**Application No: PAP/2024/0127**

**Butchers Shop, Glenside, Ansley Lane, Arley, CV7 8FU**

**Installation of roller shutters and rooflights to two-storey building, construction of a ramp to delivery area, new doors and roof covering to existing animal pens, the provision of new animal pens and storage areas for refuse and hay/straw, new site office and external alterations., for**

**Dr A Ahmed - T&S Investment Group Ltd**

JDA/517/5/1

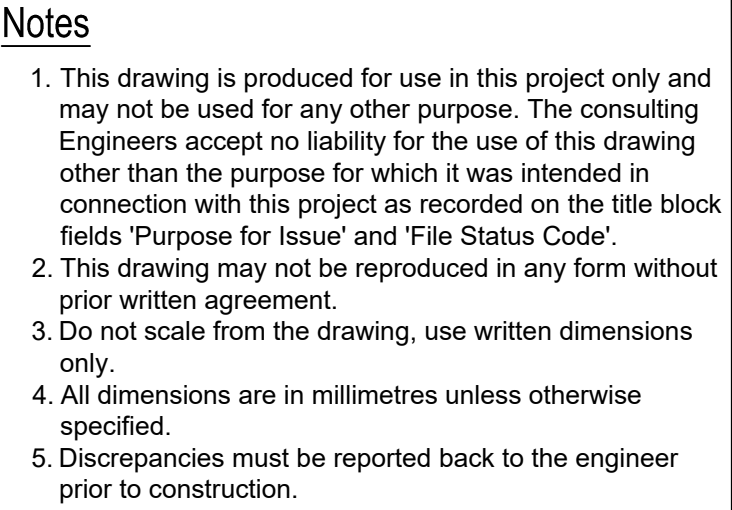
- 4.9. Furthermore, they comment that it has not been demonstrated that the visibility splays from the access points are achievable and highlight that the tracking drawings fail to account for the presence of on-street parking.

- 4.11. Finally, the authority add that parking still needs to be clarified, and there does not appear to be sufficient space for refrigerated despatch vans reverse and egress in a forward gear.
